FIELD SERVICE BULLETIN

FIELD SERVICE BULLETIN NO. 4
REVISED AUGUST 5, 1949

SUBJECT: INSPECTION OF NOSE GEAR RETRACTING DRAG LINK

EFFECTIVITY: NAVIONS, NAV-4-2 THROUGH 1150

FIGURE I

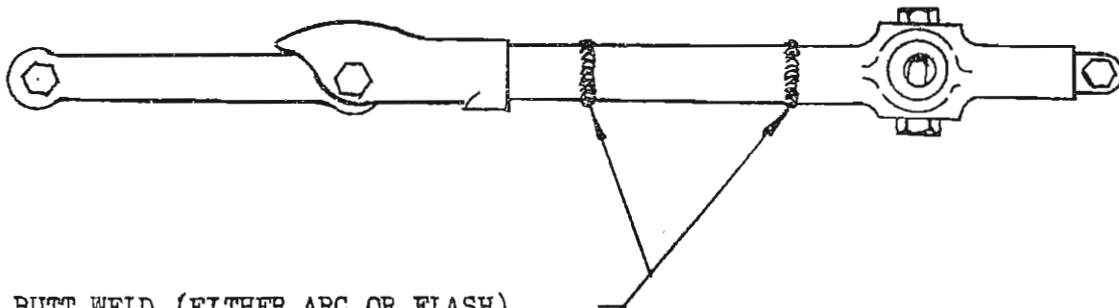
A few cases have been reported on earlier Navions where Nose Gear Retracting Drag Links, Part No. 145-34106 have failed in service. Despite the fact that a large number of these links have given many hours of service without trouble, it is considered necessary to reinforce all links having butt welds (either arc or flash) regardless of the position of the oil drain hole. Reinforced links will be furnished on an exchange basis by the Ryan Aeronautical Company and handled through authorized Ryan Navion Distributors or Dealers. Owners should contact their nearest Distributor or Dealer in advance to arrange for installation and make sure that reinforced links are available.

BUTT WELD (EITHER ARC OR FLASH)
IS UNSATISFACTORY AND BULLETIN
NO. 4 WILL APPLY

EITHER TYPE OF REINFORCEMENT IS
SATISFACTORY, BULLETIN NO. 4
WILL NOT APPLY

BOLT MUST ALLOW ABSOLUTE FREEDOM
OF KNUCKLE MOVEMENT

SHOULDER SHOULD TOUCH WHEN
IN PAST-CENTER POSITION

Install replacement links consisting of the following Part No. 145-34120 link assembly (less Part No. 145-34108 shaft) as follows:

1. Place airplane on jacks so landing gear can be operated.
2. Remove right hand engine cooling gill cover. Place a piece of dural or wood next to skin under lower nose gear bungee attachment. This is to prevent bungee from rotating too far and damaging indicating light switches.
3. Remove bolt attaching forward 145-34164 link from nose gear strut. Remove bolt connecting operating hydraulic cylinder to 145-34106 link. Remove bolt attaching 145-34106 link to bungee shaft.
4. Install reinforced link assembly by attaching link to bungee shaft with bolt previously removed. Install bolt, attaching link 145-34164 to nose gear strut. Connect hydraulic operating cylinder strut to link and safety.
5. Operate gear with hand pump at least three (3) operations, checking indicating lights and up-locks for proper functioning.
